VOGTLE ELECTRIC GENERATING PLANT - UNIT 2

Inservice Testing Program

ISI-P-016

Revision 2 Summary of Changes

DESIGNED	ET	DRAWN	DRC
TYPED		CHECKED	MS
SCALE	NONE	CHECKED ON DRAWING	
PROJ. NO.	N/A	DRAWING NUMBER	IS1-D-266
SHEET	N/A	DRAWING NUMBER	1 OF 1
REV			2

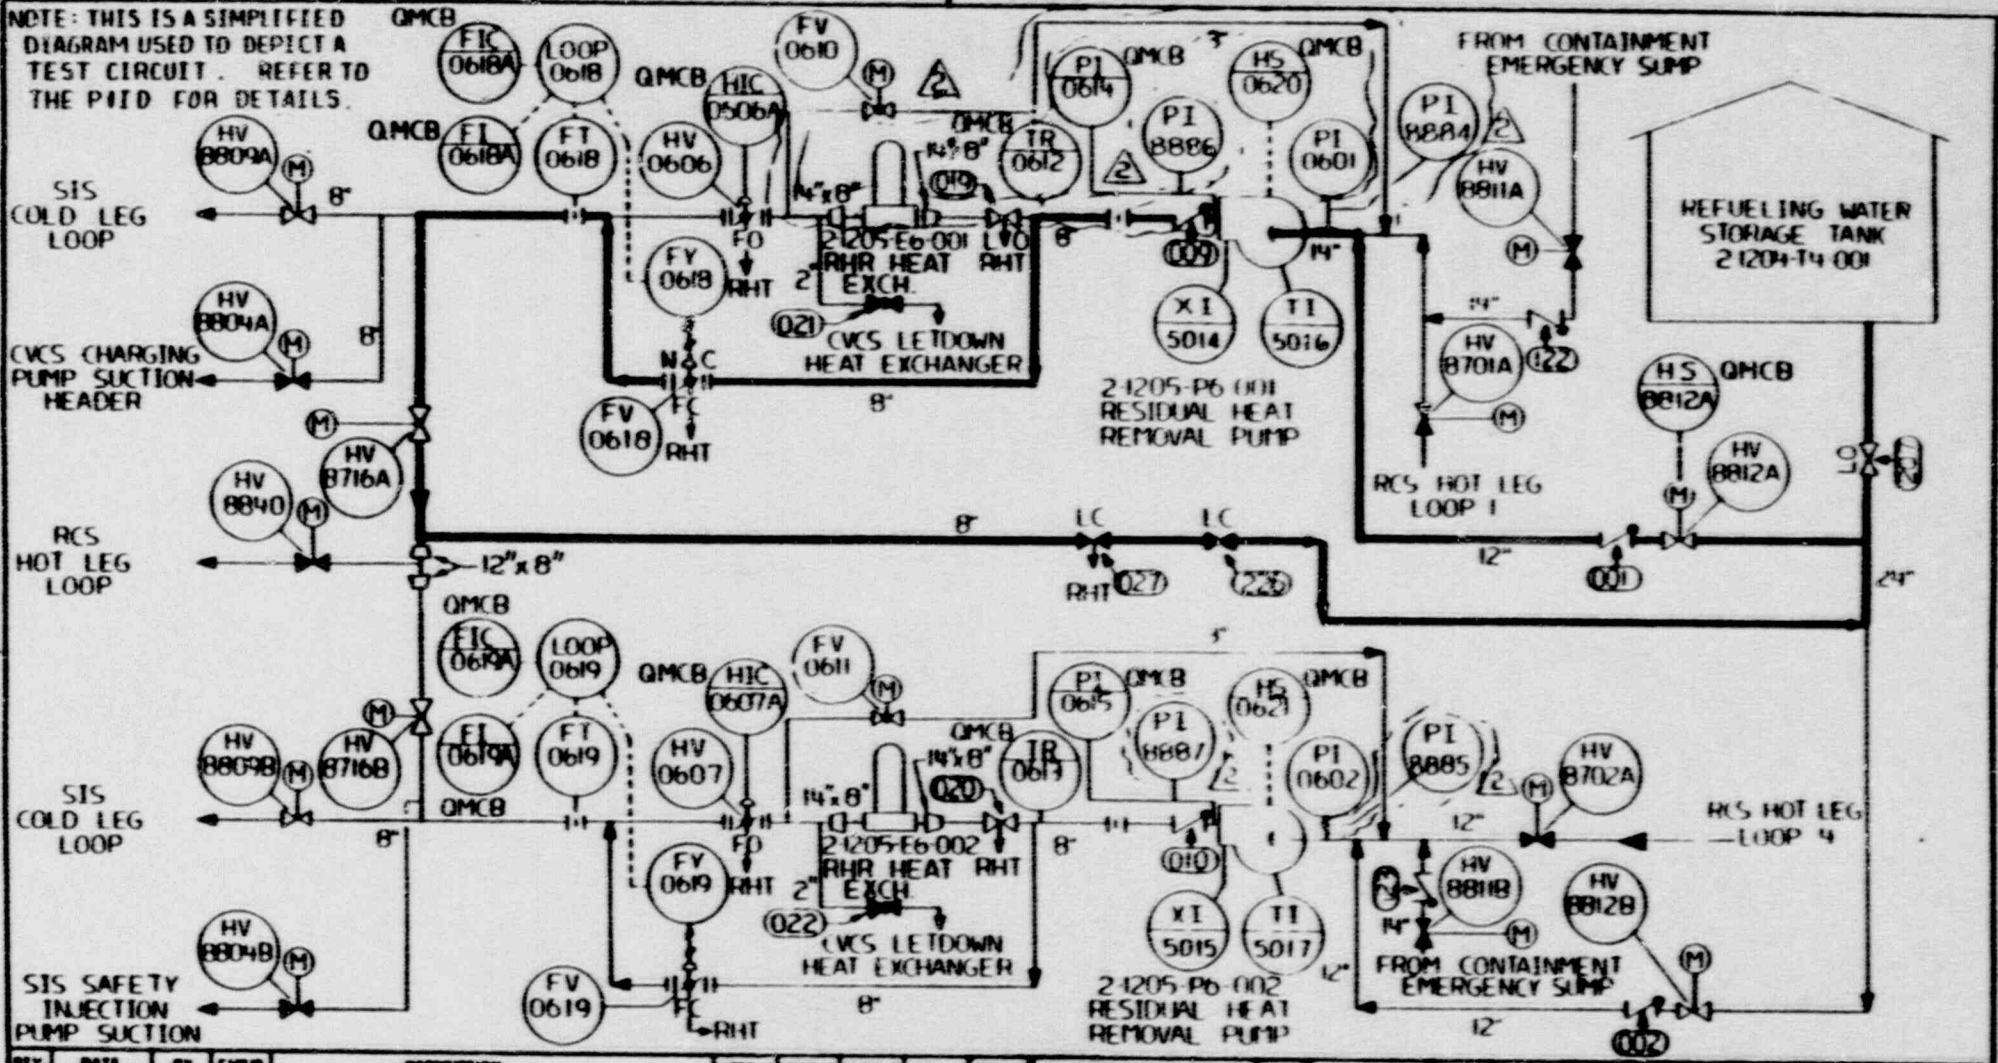
REV.	DATE	BY	CHK'D	DESCRIPTION	APPR. 1	APPR. 2	APPR. 3	APPR. 4	APPR. 5
0	9-5-84	AG	MLD	ISSUED FOR PST					
1	1-16-88	C.L.	MLD	UPDATED TO REV 17 OF 2X4DB122					
2	4-19-89	QJ	TAA	ADDED P1 8884 8885 8886 8887 DELETED FLOW TEST

DESIGNED BY	FI	CHECKED BY	JRS
DRAWN BY	NONE	APPROVED BY	
SCALE	N/A	DATE	151-D-268
SHEET	1	TOTAL SHEETS	2

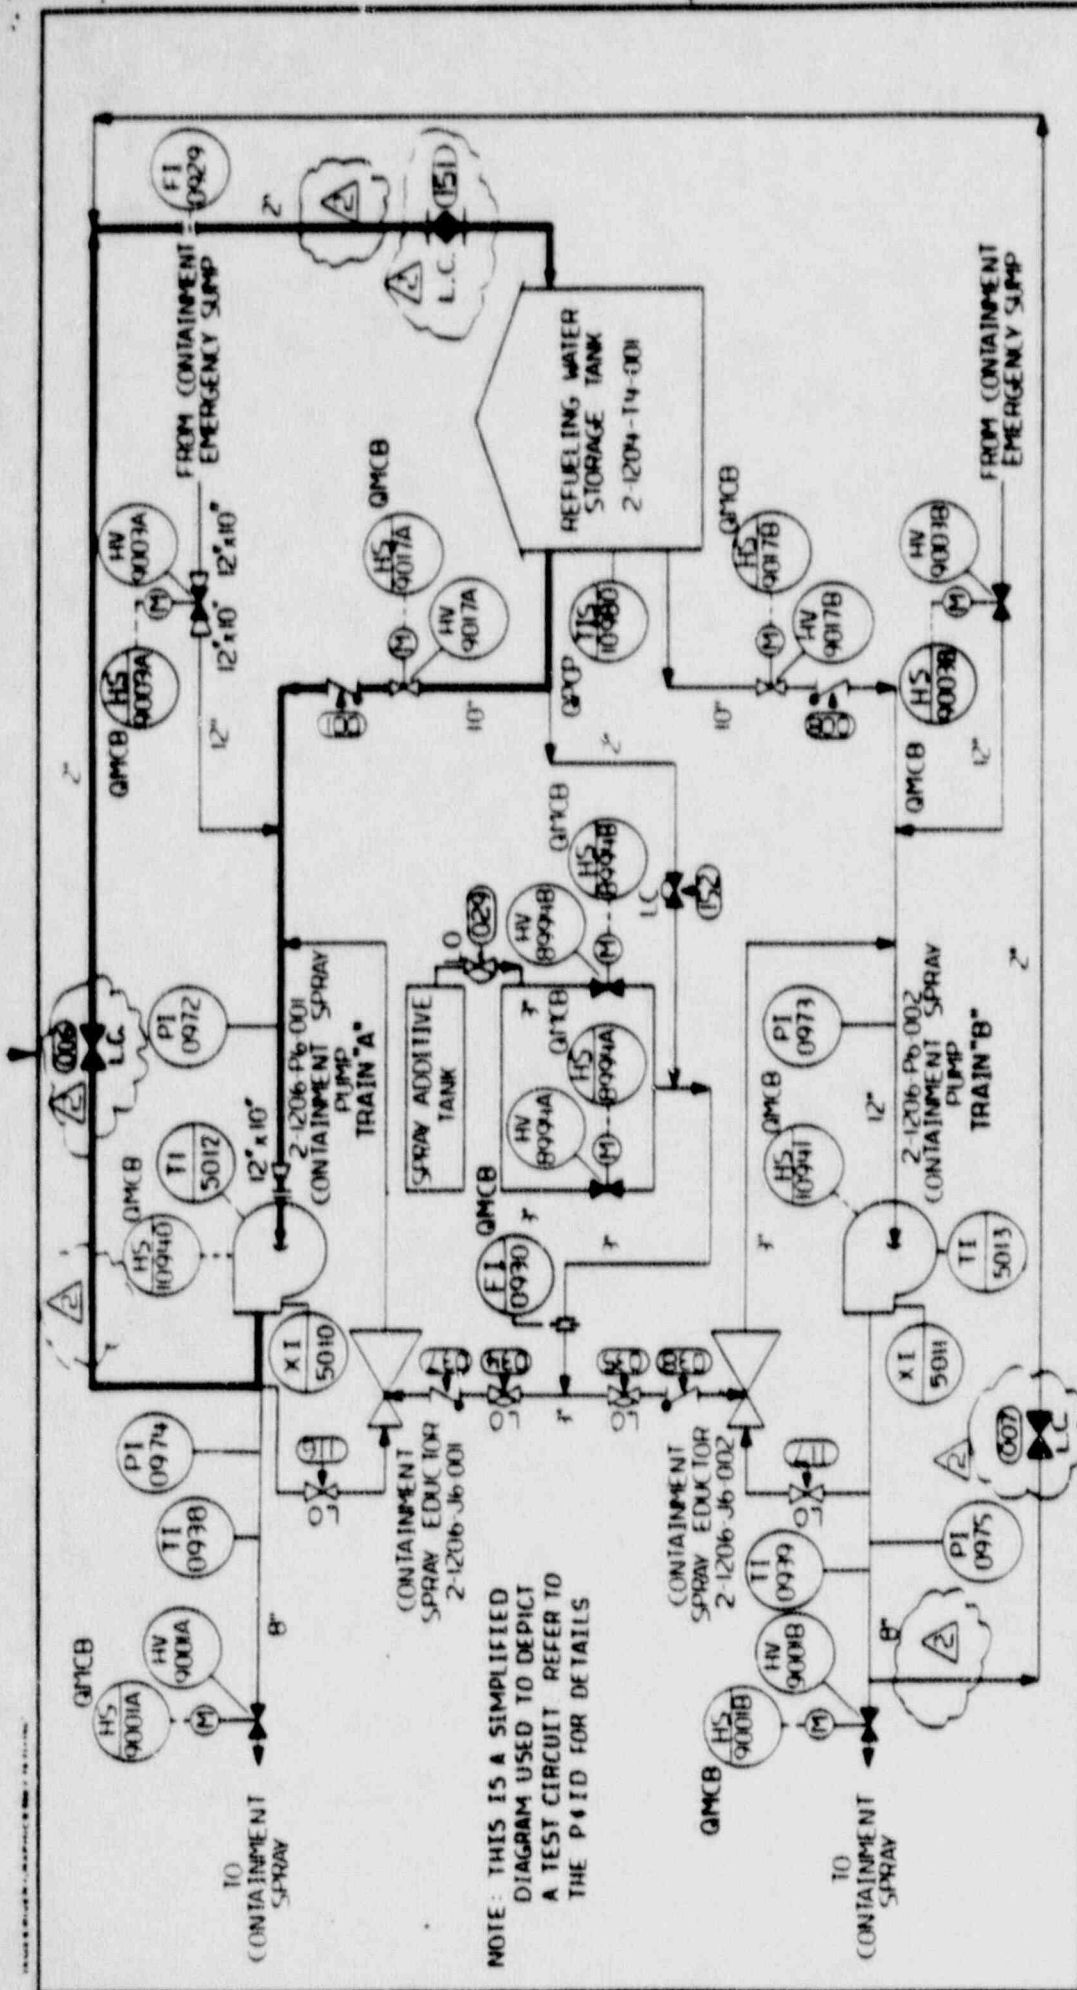
Drawings ISI-D-268 and 269	Manual globe valves 006, 007, and 151 have been replaced. Valves 006, 007 have been replaced with gate valves while valve 151 has been replaced with a plug valve. The new valves are less restrictive to flow and allow the Containment Spray Pumps to be tested at higher flow rates, thus reducing the chances of pump damage. Accordingly, program changes have been made to reflect these design changes to the plant.
Tables 4-9, 4-10 Drawings ISI-D-256, 257 Tables 5-2 thru 5-7, 7-2 and 7-3 Drawings ISI-D-266, 267 Tables 9-2, 9-3 Drawings ISI-D-270, 271	New pressure gauges have been installed that fully comply with ASME Section XI. Temporary test gauges are no longer required for pump tests. Accordingly, program changes have been made to reflect these design changes to the plant. Deleted miniflow test circuit for RHR pump testing.
Drawings ISI-D-277 and 278	Drawings were modified to show the actual flow path for testing.

REV	DATE	BY	CHKD	DESCRIPTION	ISSUED FOR	APPROVED	DATE
1	1-16-88	JMB	JMB	ISSUED FOR P&ID			
2	4-19-87	JMB	JMB	UPDATED TO REV 15 OF 28408131 REVISED VALVES-0006, 0074, 151
